**CONSOLIDATED EDISON COMPANY OF NEW YORK, INC.
INDIAN POINT NUCLEAR GENERATING UNIT NO. 3**

**THIRD SUPPLEMENT TO:
PRELIMINARY SAFETY ANALYSIS REPORT**

Supplement 2 to the Preliminary Safety Analysis Report for Indian Point Nuclear Station No. 3 consists of responses to the AEC Questions on Containment Design requested in the letters of February 19, 1968 and July 16, 1968 to Consolidated Edison Company of New York.

Figure 2.4(b)-2
Supplement 2

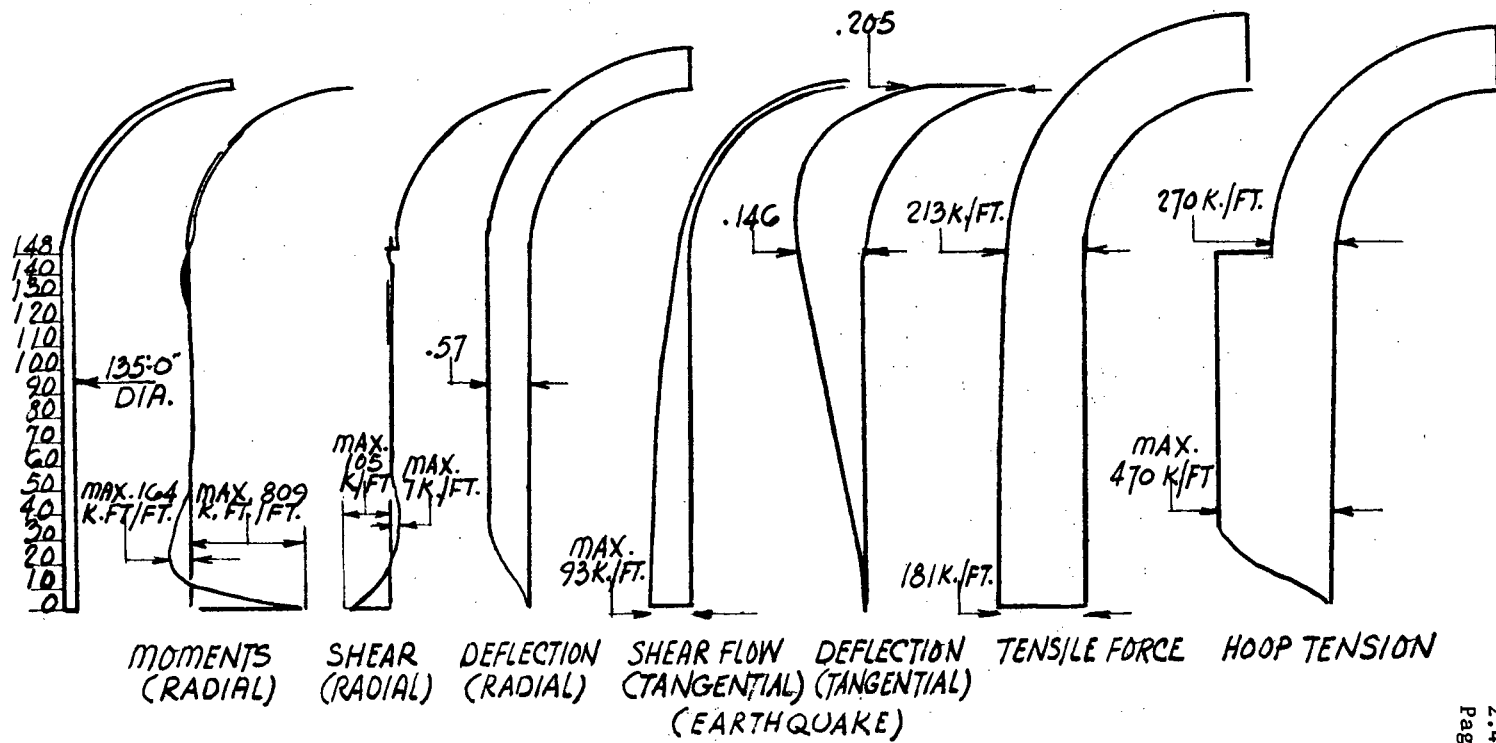
- (b) Scaled load plots for moment, shear, deflection, longitudinal force, and hoop tension, in order that an appraisal can be made of the significance of the various loadings which influence the containment design. Provide these plots for several containment heights for the following loadings: dead, pressure, operating basis earthquake (smaller earthquake), wind, liner thermal (normal and accident) and concrete thermal (normal and accident).

The design loads resulting from the factored load equations presented in Section 5.1.2.4 of the PSAR are shown in Figures 2.4(b)-1 through 2.4(b)-3. Individual load plots are shown in Figures 2.4(b)-4 through 2.4(b)-8.
